**MU-2**

SERVICE RECOMMENDATION

No.049/76-002	DATE: Jun. 29, 2018
Subject:	Propeller Pitch Control Lever Secondary Retention Feature, Installation of
Effectivity:	MU-2B-25/-26/-26A/-40: S/N 313SA, 321SA, 348SA through 459SA MU-2B-36A/-60: S/N 661SA, 697SA through 1569SA
Purpose:	To add a secondary retention method to secure the Propeller Pitch Control (PPC) lever, install the secondary retention feature (screw, washer(s), spacer, and safety wire) in the threaded end of the PPC input shaft.
Compliance:	Optional
Approval:	Engineering aspects of this Service Recommendation are FAA approved.
Responsible Agency of Compliance :	MU-2 Owners/Operators
Disposition of Removed Parts:	Scrap
Spare Parts Affected:	Yes
Required Man Hours:	Approximately 2 man hours
Special Tools Required:	None
Weight and Balance Change:	None
Flight Manual Revision:	None

No. 049/76-002

Figure 1 Installation of Secondary Retention Feature

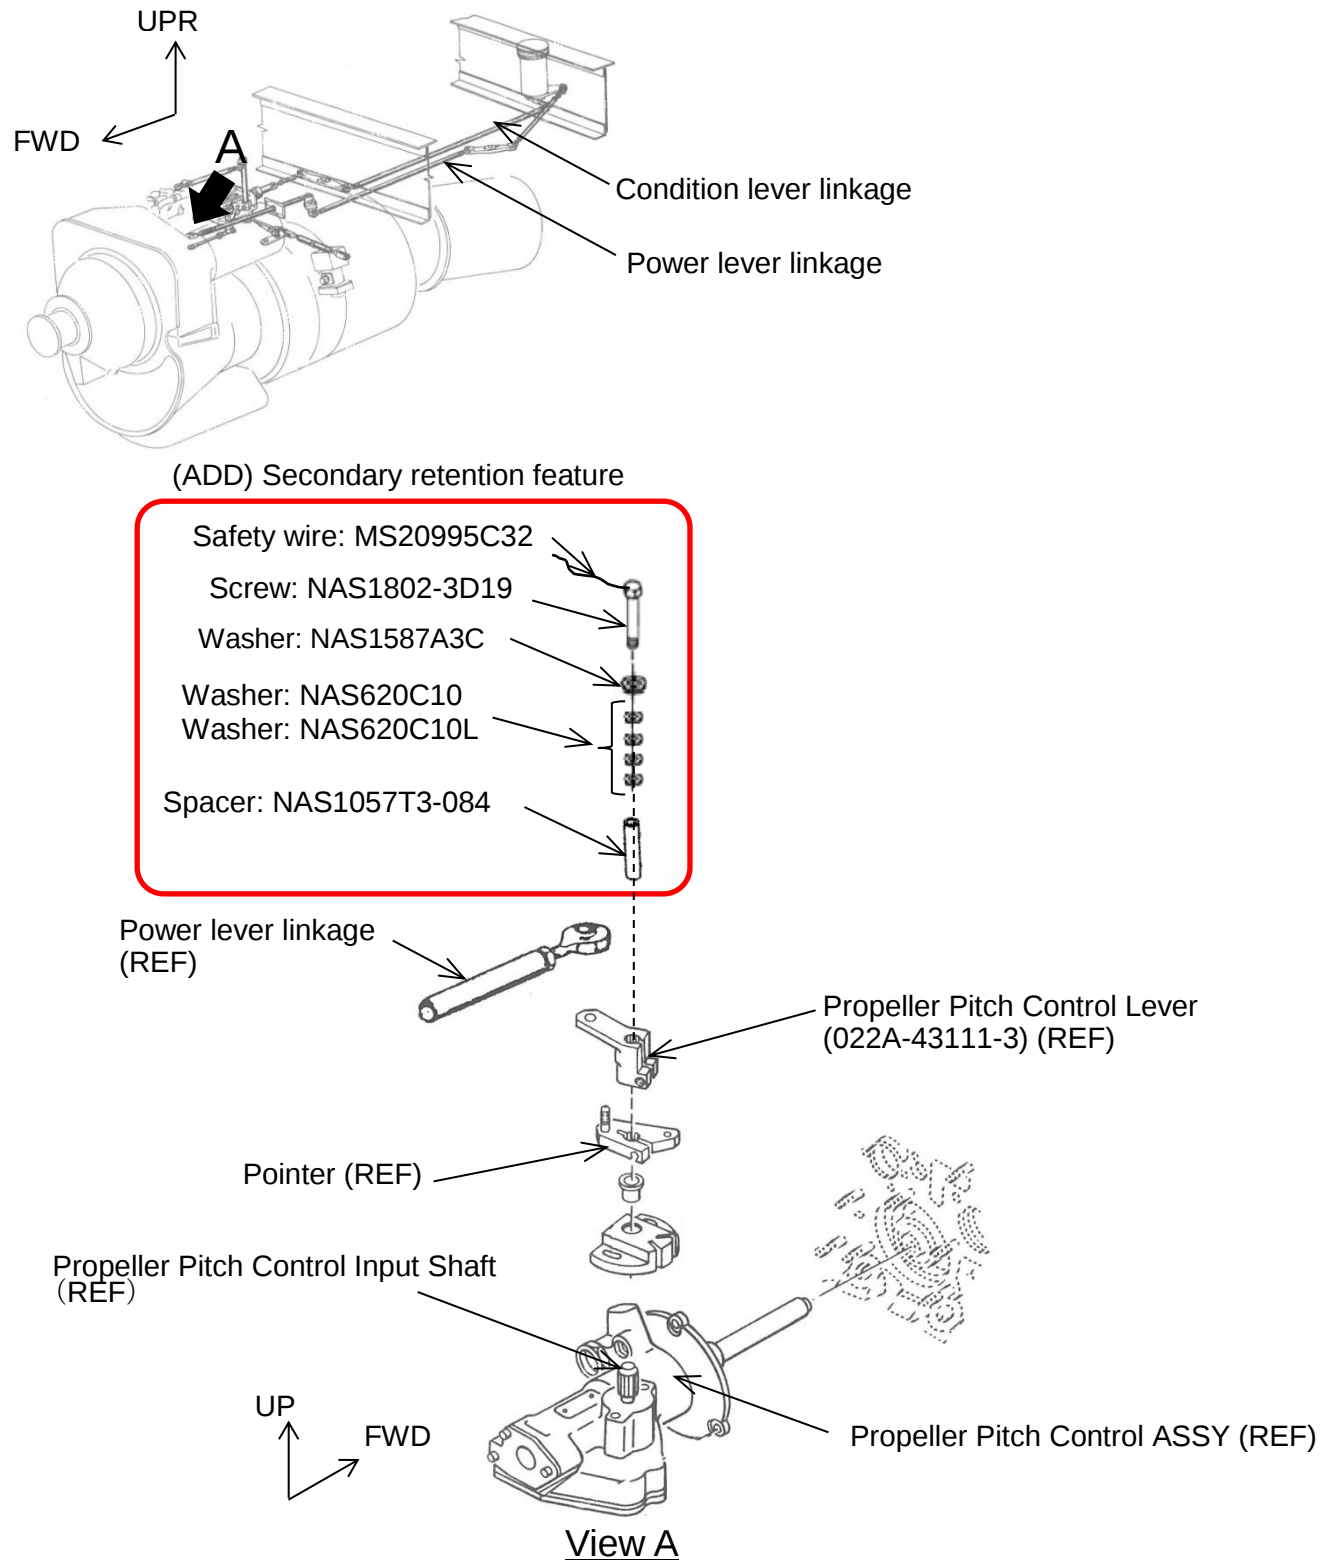
- (2) Re-torque the clamping bolt (MS20073-03-05) to 20 to 25 lbs.
- (3) Install screw (NAS1802-3D19), counter washer (NAS1587A3C), gap adjustment washers (NAS620C10 and NAS620C10L), and spacer (NAS1057T3-084) to the threaded end of PPC shaft. (Ref to Figure. 1)
 - 1) Gap adjustment for Woodward Fuel Control Pointer:
 - Use one (1) NAS620C10 and zero (0) NAS620C10L for nominal
 - 2) Gap adjustment for Bendix Fuel Control Pointer:
 - Use two (2) NAS620C10 and zero (0) NAS620C10L for nominal

- (4) Verify that there are at a minimum two (2) full turns of engagement between screw (NAS1802-3D19) and Propeller Pitch Control Input Shaft threaded hole. Torque the screw (NAS1802-3D19) to 10 to 15 in-lbs. Screw (NAS1802-3D19) does not bottom out inside the threaded shaft once required torque is achieved. 1/16" longer or shorter screw may be installed instead of screw (NAS1802-3D19) to obtain required thread engagement.

Figure 2 G: Gap between washer(NAS1578A3C) and PPC lever

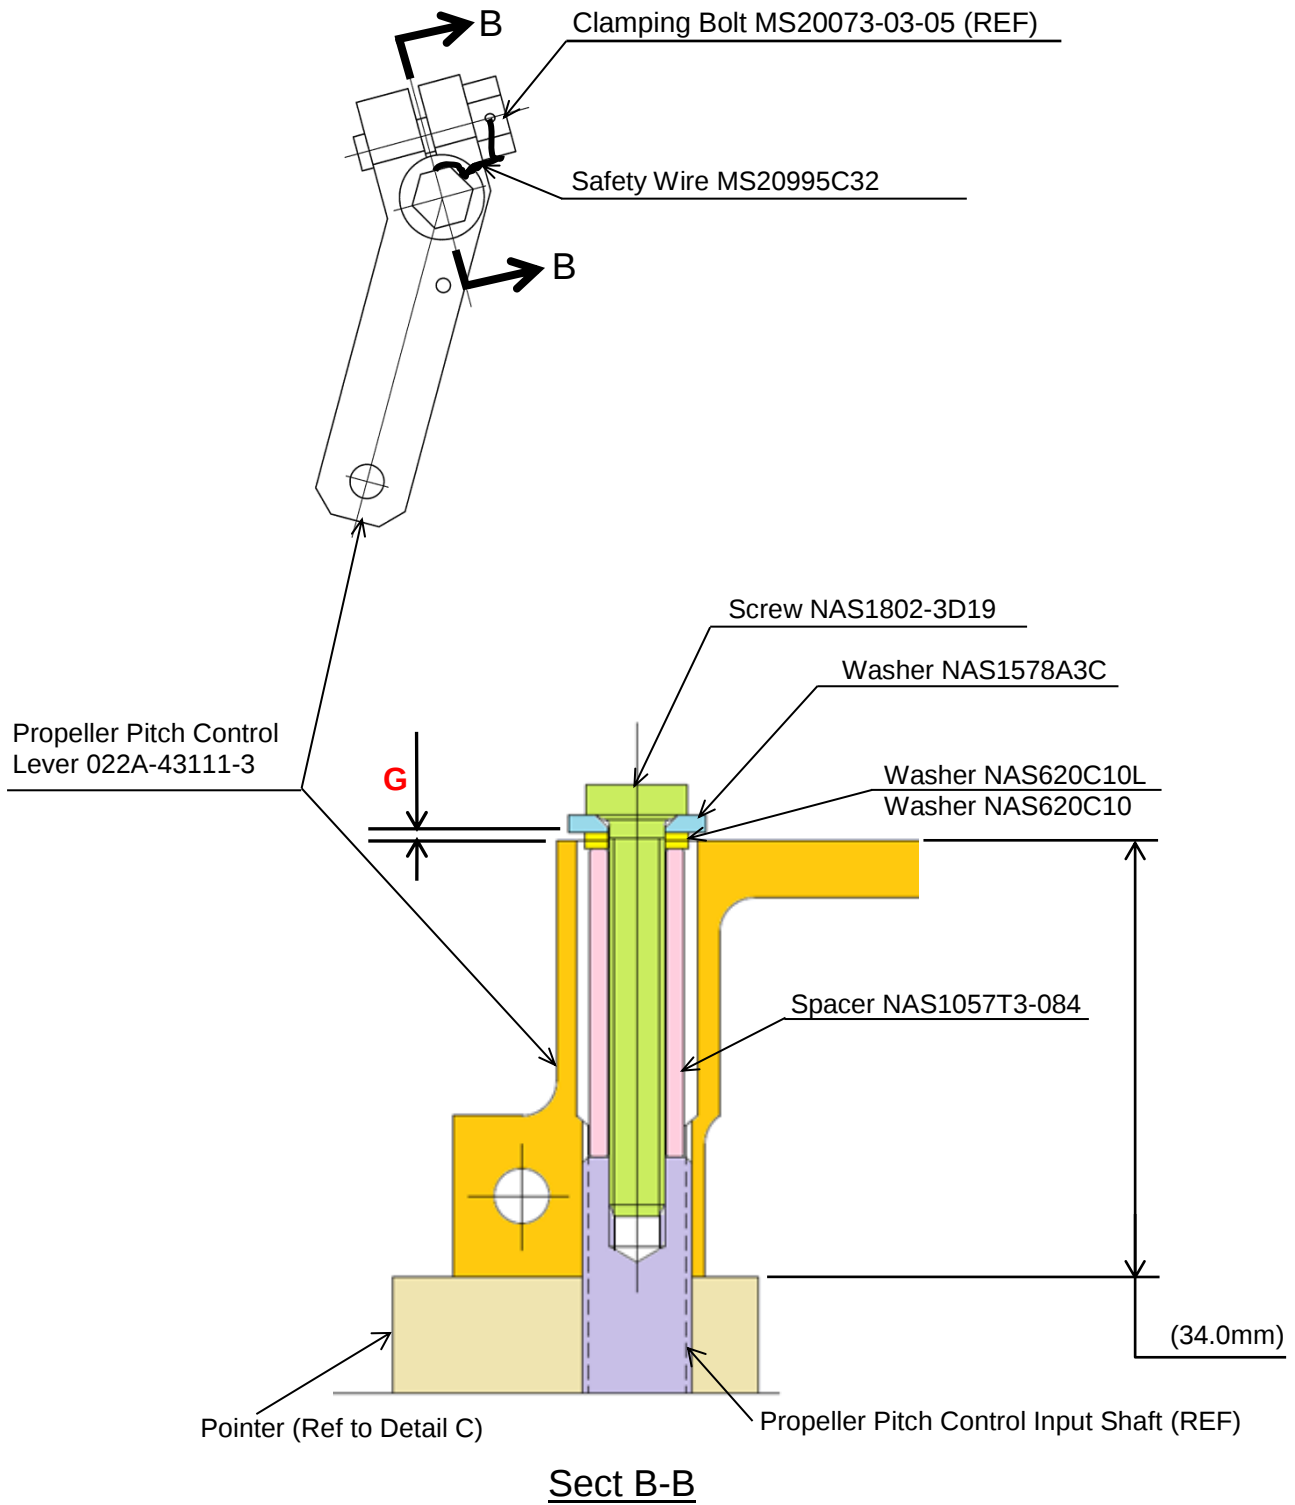
- (5) Measure the gap "G" (Ref to Figure. 2). If the gap measures $0 < G \leq 2.0$ mm, go to step (7). If out of range, go to step (6).
- (6) Add or remove washers (NAS620C10 and/or NAS620C10L) and repeat steps (3) to (5) until the gap "G" measures $0 < G \leq 2.0$ mm. 1/16" longer or shorter screw may be installed instead of the screw (NAS1802-3D19) for gap adjustment.
